Permit Application Review

Permit No. 2020-24
Received complete: April 14, 2020

Applicant: Joe Feldmann; Feldmann Imports Mercedes-Benz
Consultant: Nick Adam; Rehder and Associates, Inc.
Project: Mercedes-Benz Autohaus Renovation
Location: 4901 American Boulevard West: Bloomington
Rule(s): 4, 5
Reviewer: BCO/LLH

6
C4
SUBSURFACE INFILTRATION BASIN
CROSS SECTION
NO SCALE

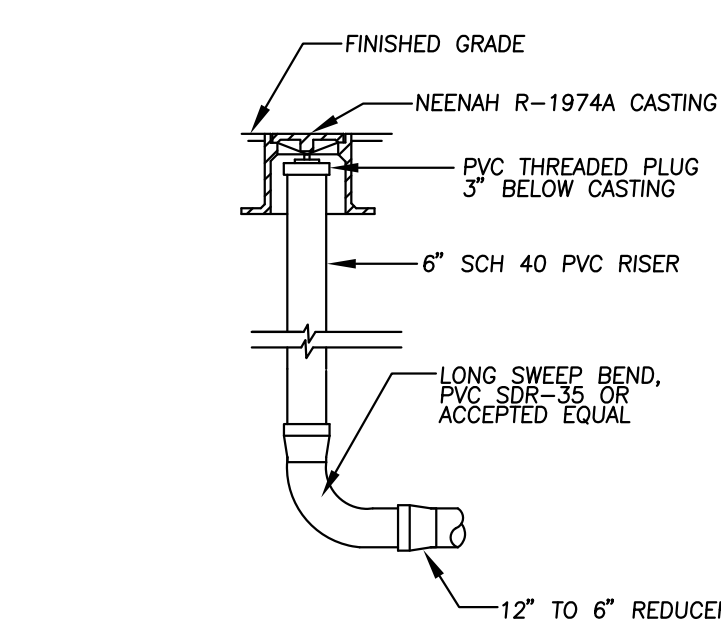
The proposed underground infiltration system consists of 12-inch diameter perforated HDPE pipe surrounded by washed river rock beneath the pavement. The plans indicate the stormwater management facility sides and top will be wrapped with geotextile filter.

The soil borings performed by American Engineering Testing, Inc. on May 20, 2009 near the proposed stormwater management system indicate lean clay (CL), silty sand (SM) and clayey sands (ML) at varying depths below the surface. Where Type CL and ML soils are encountered, the plans identify excavation of soils to depths where SM soils are present (approximately 832.8 M.S.L.). These areas will be filled with clean construction sand to elevation 837.0 M.S.L., the identified bottom of the underground infiltration system. The over excavation is anticipated to be required in the area of soil boring B-11. As identified by the stormwater management modeling, a design infiltration rate of 0.45 inches/hour was used based on Minnesota Stormwater Manual soil classification infiltration rates for HSG Type B soils.

The proposed bottom of the underground infiltration system is 837.0 M.S.L. The UGSWMF system outlet invert elevation is 838.8 M.S.L., resulting in an infiltration system depth of 1.8 feet. An infiltration volume of 799 cubic feet is required for 1.1-inches of runoff from the 0.20 acres of regulated impervious area. A volume of 836 cubic feet is proposed to be provided (799 cubic feet required) with an area of 1,100 square feet (444 square feet required) at an inundation depth of 1.8 feet. Rule 4.3.1a is met.

6. Per Rule 4.5.4e, submittal of a plan with the design detail for the underground infiltration system outlet control structure on the plans. A detail of the outlet control structure is required prior to issuance of the permit.
